DOCUMENT 00911

ADDENDUM NUMBER 1

Issued: December 9, 2010

**1315 Airport Boulevard Tenant Improvements
(Architectural Construction, Site Work, and Electrical)**

DRAWING NUMBER: C-1 SHEET 3 OF 50

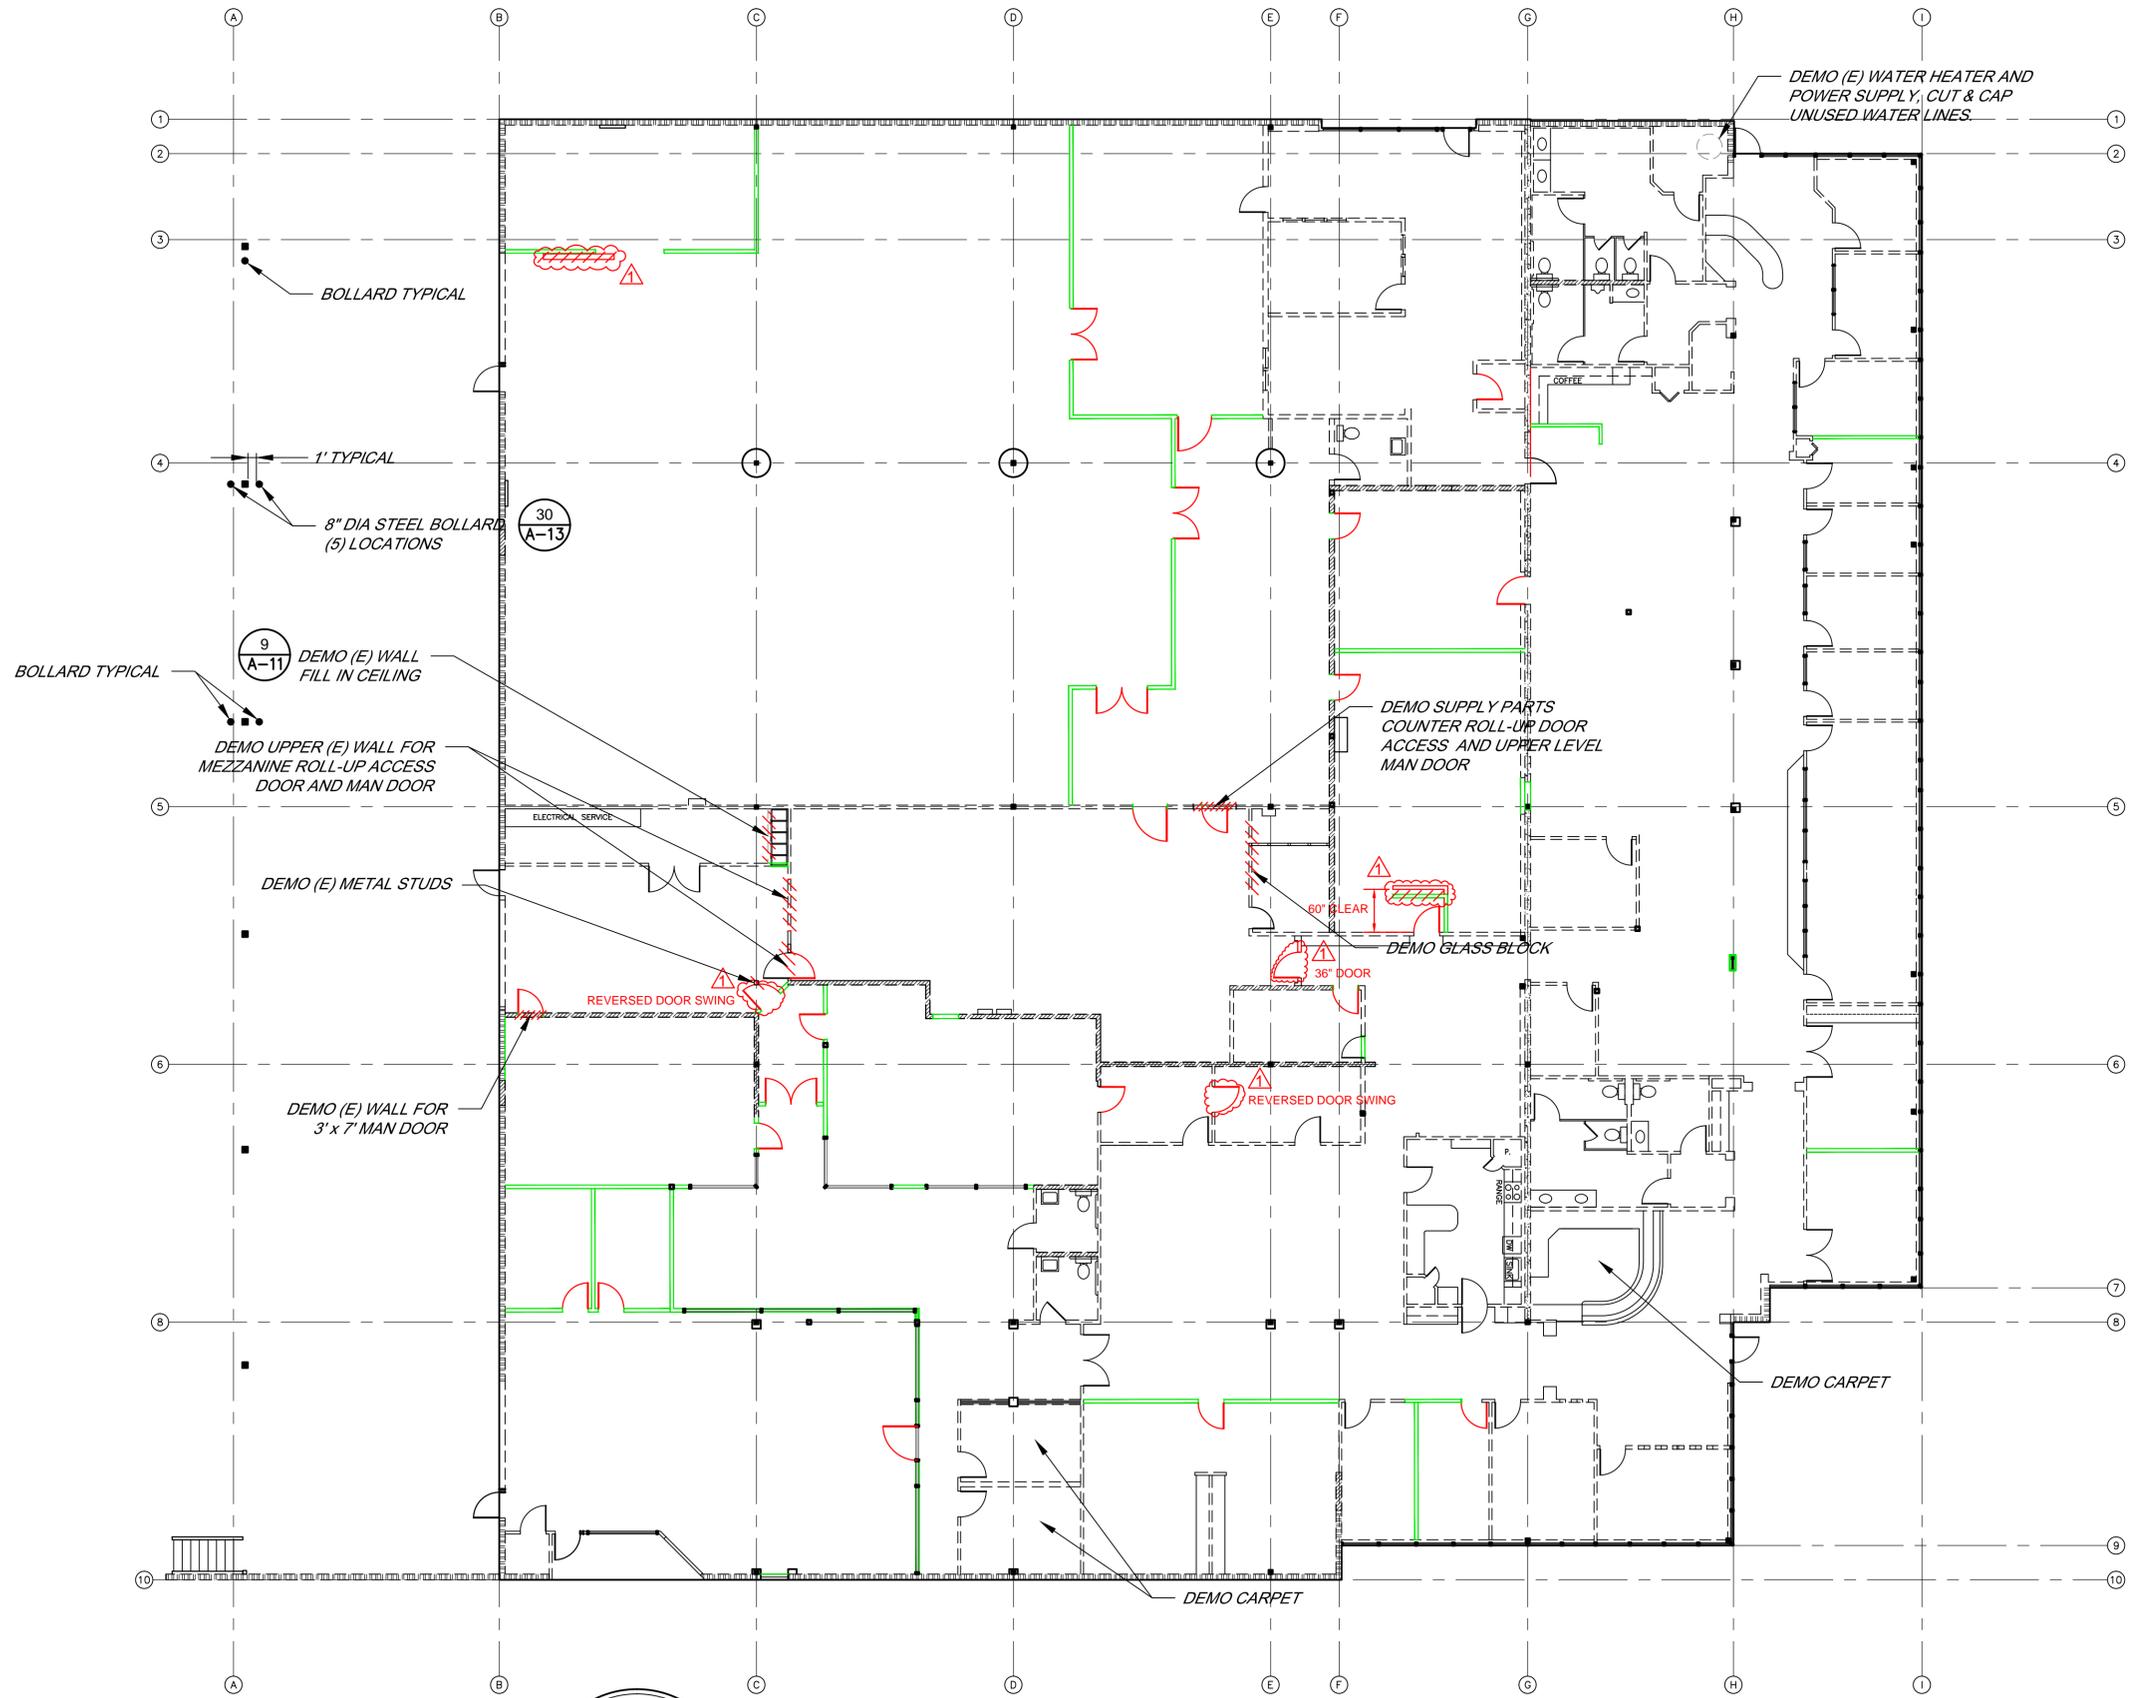
- A. Delete Drawing C-1 and replace with attached Drawing C-1, marked "12-8-2010 Addendum No. 1."
- B. Delete Drawing A-2 and replace with attached Drawing A-2, marked "12-8-2010 Addendum No. 1."

1. RFI: Sheet C-1 spells out new slurry seal on a portion of east parking lot - Specifications states "Slurry Seal: Per Caltrans 37" - Is this referring to Caltrans Slurry Seal 37-2?

1. Is there a drawing or spec for the gate itself? Sheet C-1 doesn't tell you much. Specs only spec out Electric Gate operator for a heavy duty commercial slide gate operator.

1. Repair damaged cross-brace and barbed security wire (at West entrance)
2. Modify West rolling gate to accept and operate with motorized operator per Section 02829 (Electric Gate Operator).
3. Demolish existing East gates (2) and install new 14' rolling gate, match existing, with motorized operator per Section 02829 (Electric Gate Operator). Install new fencing as needed to accept new 14' East rolling gate as indicated.
2. Modify paragraph 1.2A.1 (prior to renumbering 1.2A.1) as follows:
 - a. Scaled plan layout showing new gate location, fence, and post anchorage.
3. Modify paragraph 1.2B.1 (prior to renumbering 1.2B.1) as follows:
 - a. Chain link fence and gates, including modification materials
4. Insert the following after paragraph 2.2H:
 - I. Gates:
 1. Rolling, on track

FILE NAME: A_SCWA_1315Airport_ReflectedCeiling-A-10.dwg DRAWING NUMBER: A-10 SHEET 13 OF 50

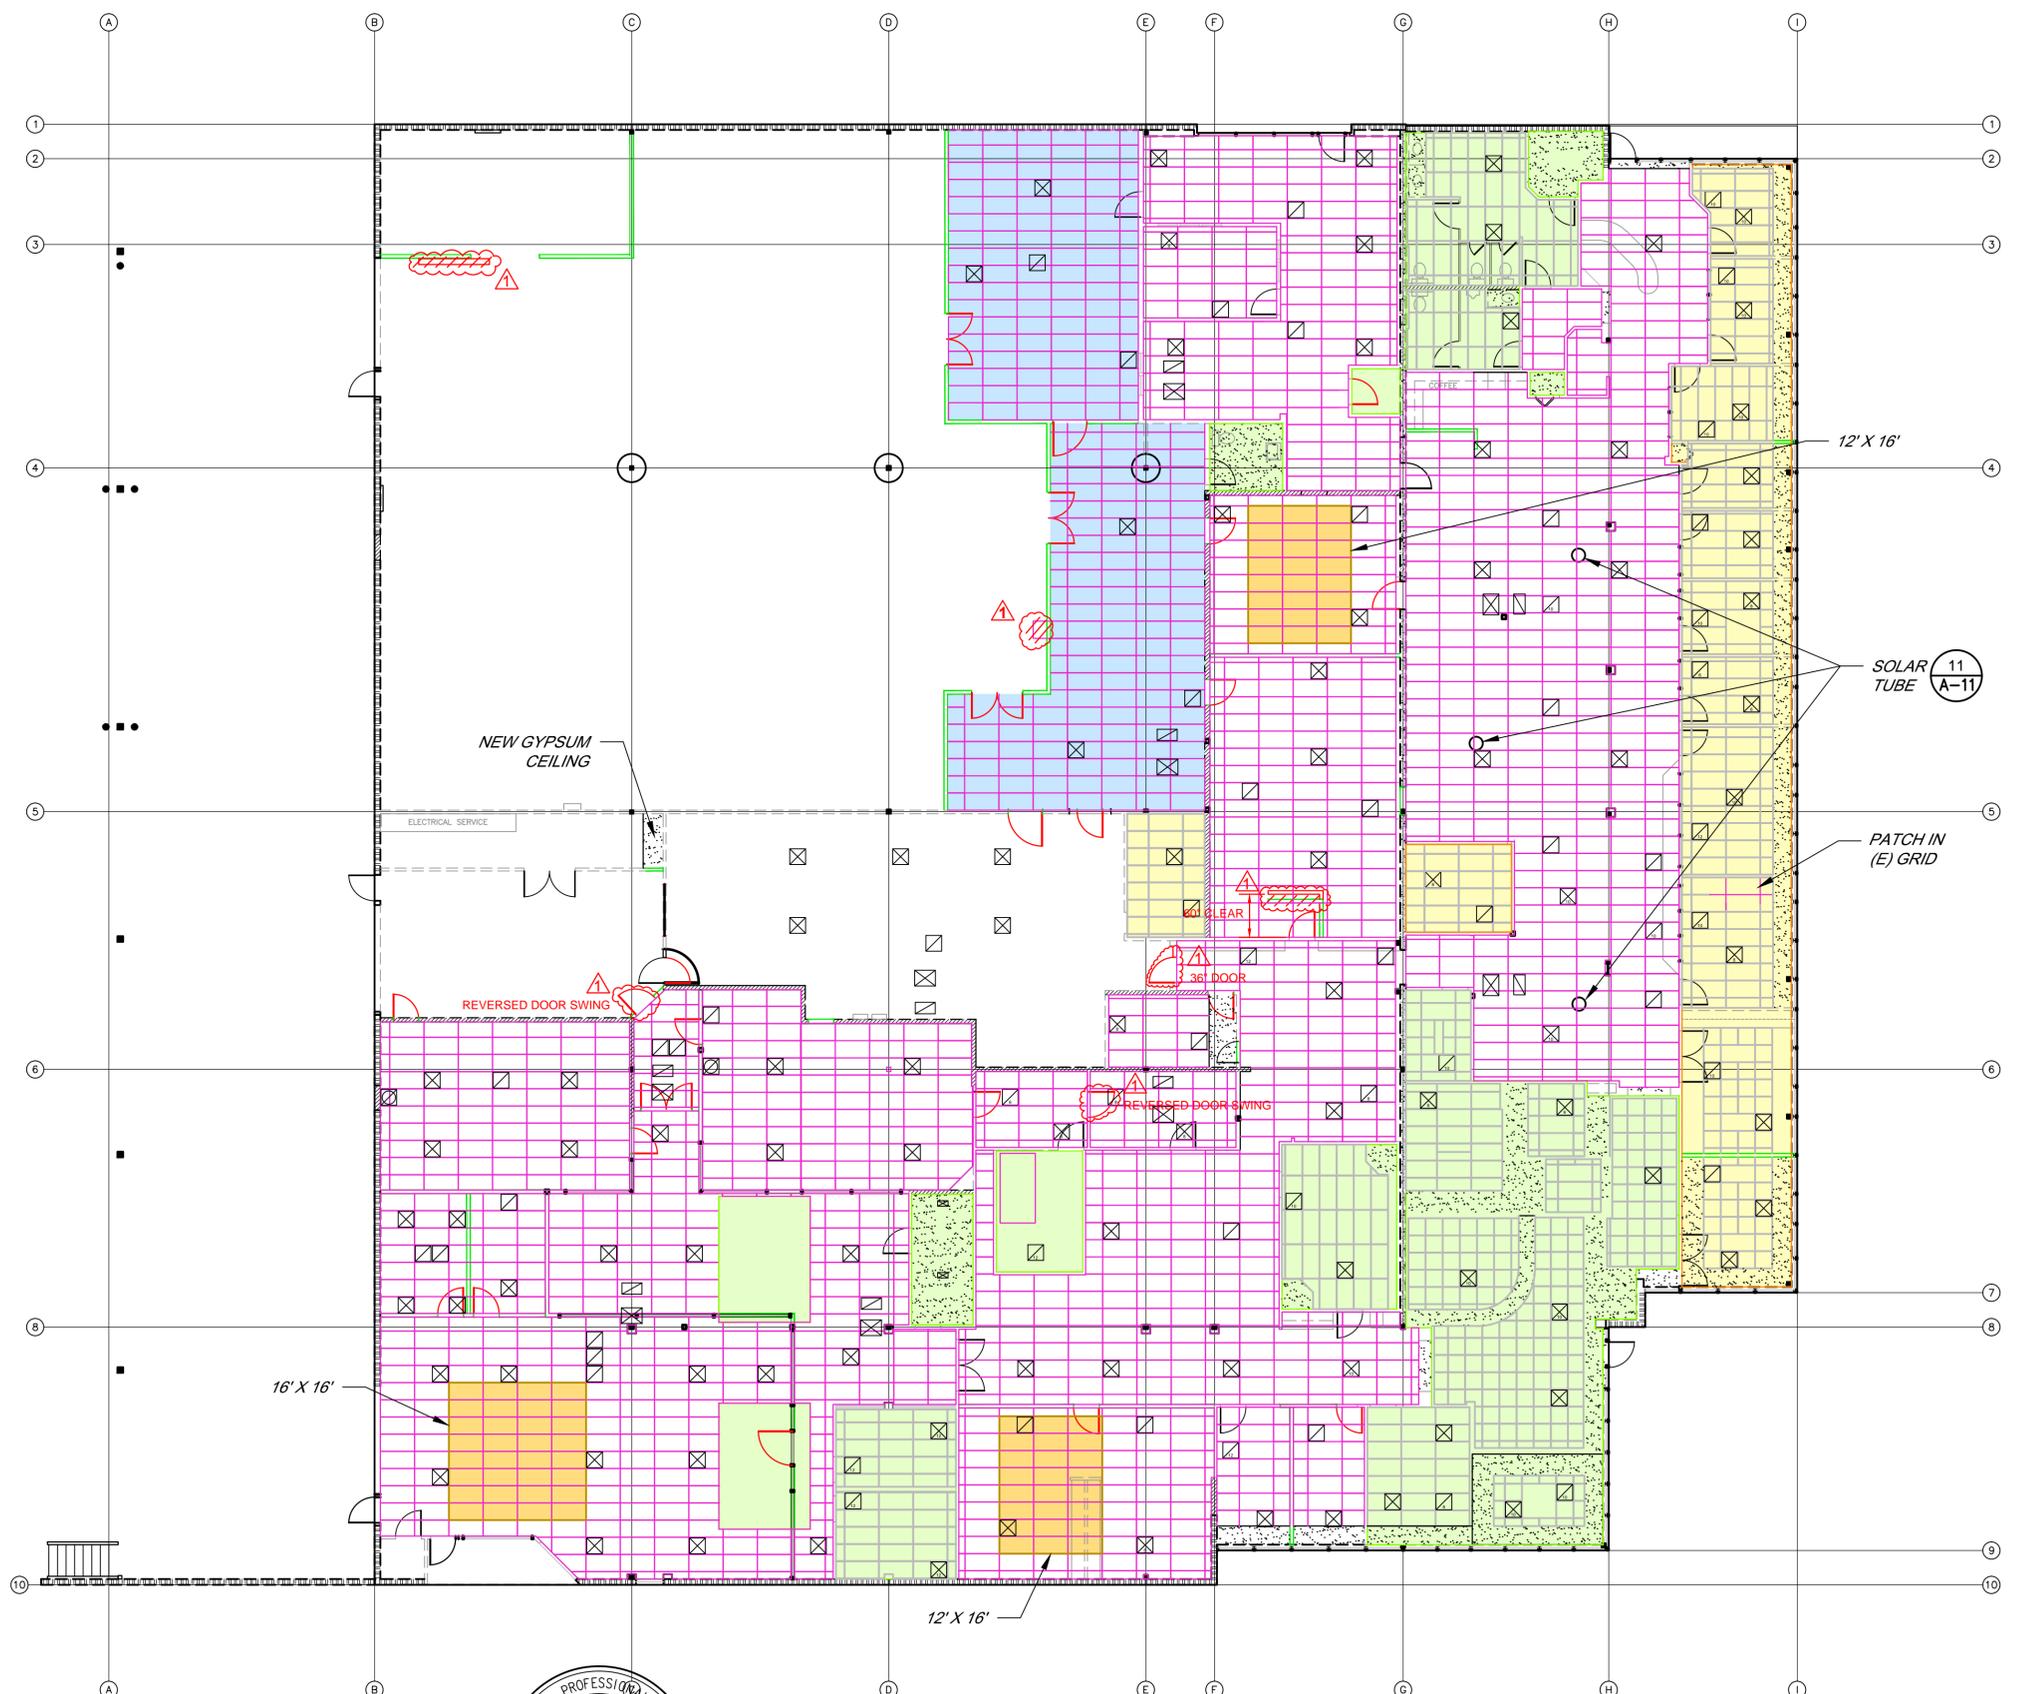
2. The reflected ceiling plan calls for opaque or translucent ceiling panels in three areas. There is no specification for the opaque or translucent ceiling panels. Please provide specifications.

4. The reflected ceiling plan, A-10, and the roof plan, A-16, show three tubular skylights. There are no specifications for the skylights. Please provide specifications.

2.4 CEILING LIGHT PANELS

A. Manufacturer: OPTIX Acrylic Cracked Ice Ceiling Light Panel, or Approved Equal.

B. Size: 4 ft x 2 ft

DRAWING NUMBER: A-15 SHEET 18 OF 50

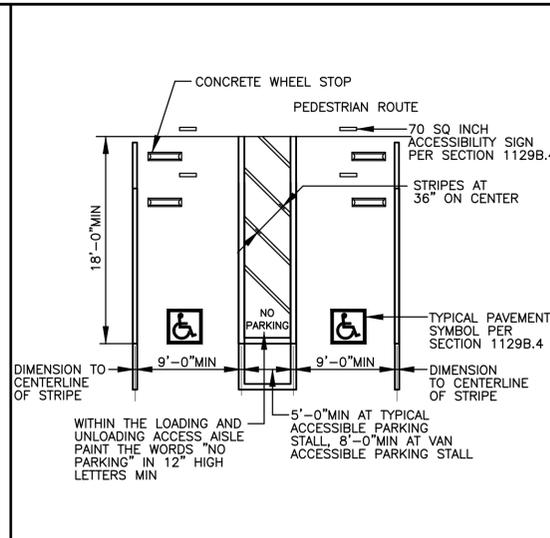
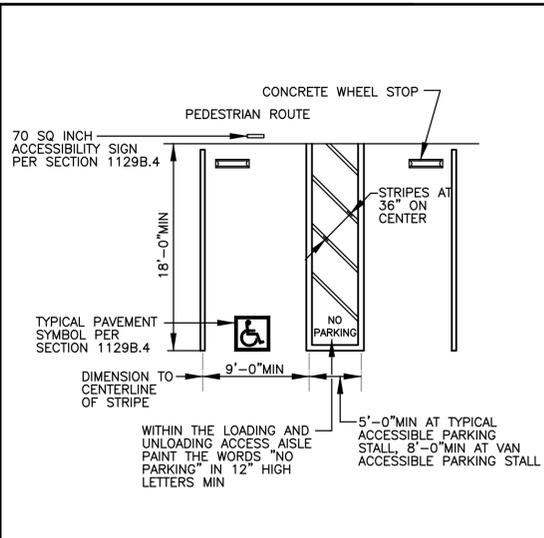
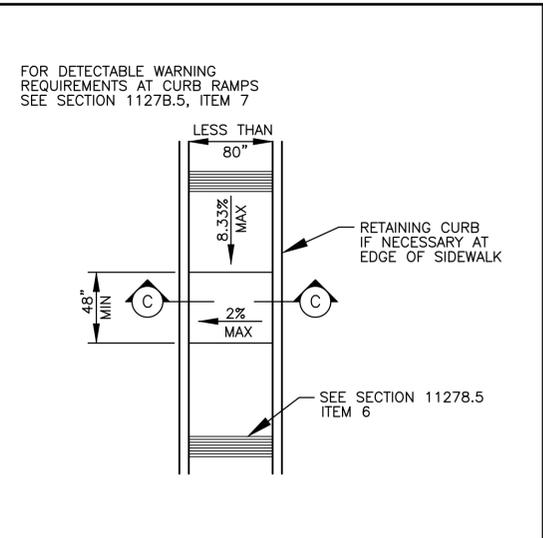
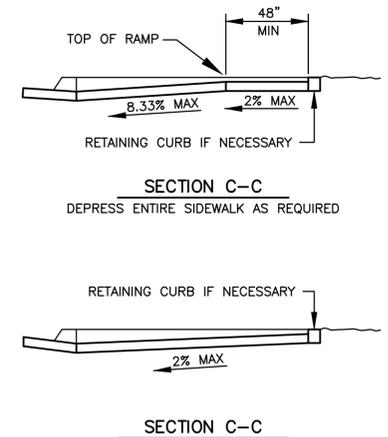
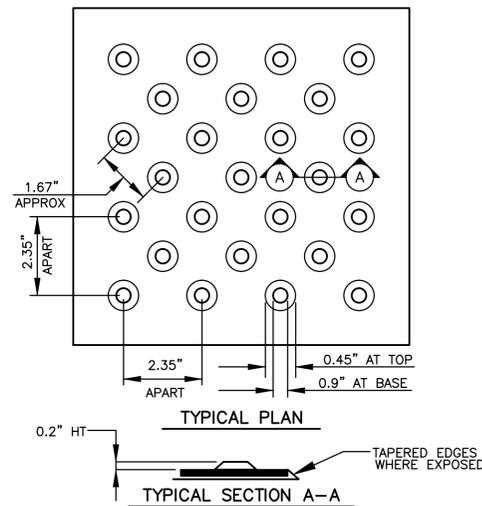
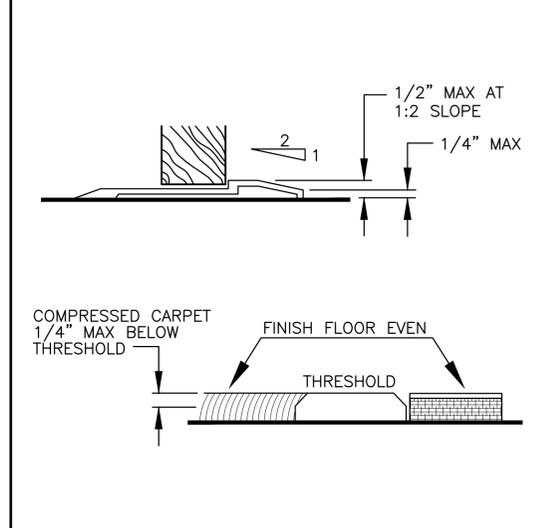
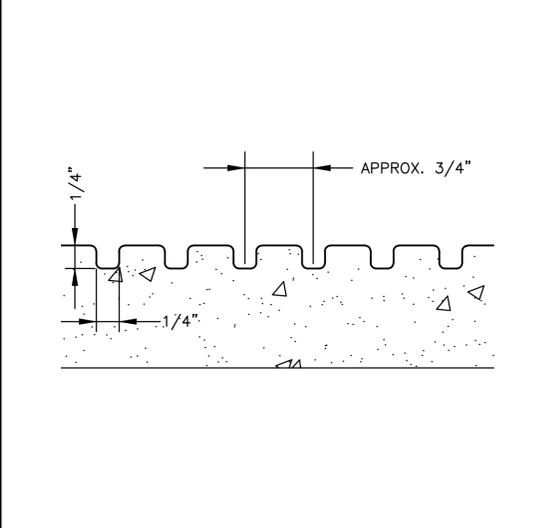
- K. Delete Drawing A-15 and replace with attached Drawing A-15, marked "12-8-2010 Addendum No. 1."
- L. Delete Drawing A-17 and replace with attached Drawing A-17, marked "12-8-2010 Addendum No. 1."

6. Sheet A-15 shows a detail for truncated domes, but sheet C-1 does not show any to be used. Please confirm there are no truncated domes on this job.
